DART AEROSPACE LTD	Work Order:	149846
Description: Crosstube Assembly	Part Number:	D407-667-145
Inspection Dwg: D407-667-145 Rev: C		Page 1 of 2

DRAWING NO. D407-667-145	TITLE CROSSTUBE ASS'Y (407 HIGH FWD)	REV. C	DART AEROSPACE LTD ENGINEERING ORDER		D.E.O. NO. D407-667-145-C-1	SHEET NO. SHEET 1 OF 1	SCALE NTS
DRAWN qp	CHECKED ASS	MFG. APPR. iB	APPROVED WD		DE APPR. H		
DATE 11.07.15	DATE 11.07.22	DATE 11.07.22	DATE 11/07/22		DATE 11.07.21

DRAWING NO. D407-667-145	TITLE CROSSTUBE ASS'Y (407 HIGH FWD)	REV. C	DART AEROSPACE LTD ENGINEERING ORDER	D.E.O. NO. D407-667-145-C-2	SHEET NO. SHEET 1 OF 1	SCALE NTS
DRAWN AJS	CHECKED [Signature]	MFG. APPR. [Signature]	APPROVED [Signature]	DE APPR. [Signature]		
DATE 12.08.02	DATE 12.08.02	DATE 12.08.02	DATE 12.08.02	DATE 12.08.02	DATE 12.08.02

DETAIL P
BONDING STRAP INSTALLATION 2 PL

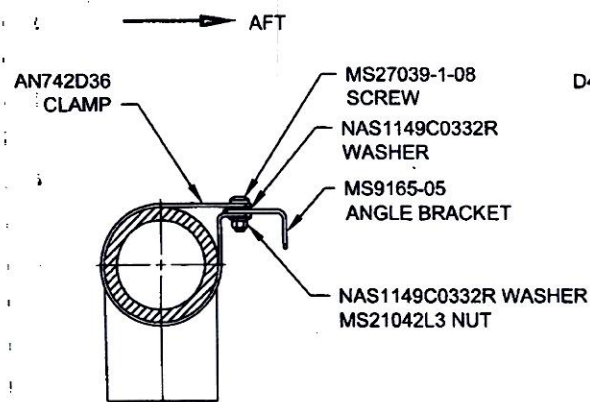
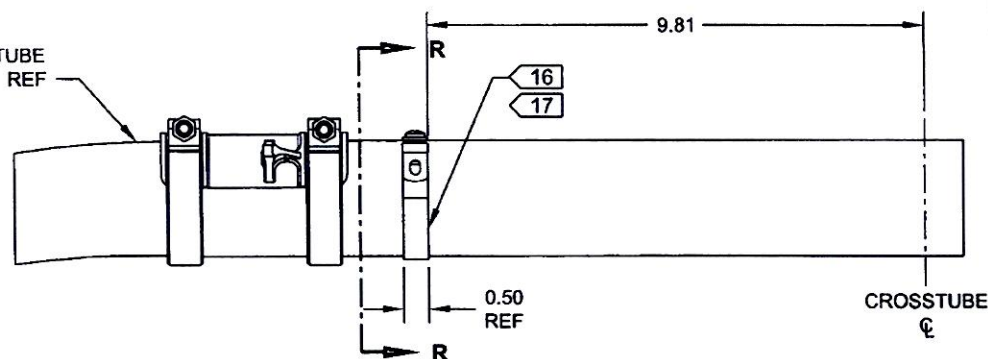
ADD ELECTRICAL GROUNDING STRAP

ITEM	QTY -145	PART NUMBER	DESCRIPTION
1	X	D407-667-145	CROSSTUBE ASSEMBLY (407 HIGH FWD)
10	2	AN742D36	CLAMP
11	2	MS9165-05	ANGLE BRACKET
12	2	MS21042L3	NUT (OR MS21042-3)
13	2	MS27039-1-08	SCREW
14	4	NAS1149C0332R	WASHER (OR AN960C10L)

- 16) MASK AREA UNDER CLAMP PRIOR TO PAINTING
- 17) SEAL EDGES WHERE AN742D36 CLAMP MEETS WITH THE CROSSTUBE USING SIKAFLEX-241/-291 OR MIL-S-8802 CLASS B2 OR PROSEAL 890 SEALANT
- 18) PERFORM RESISTANCE CHECK TO ENSURE MAX RESISTANCE IS 10 MILLIOHMS
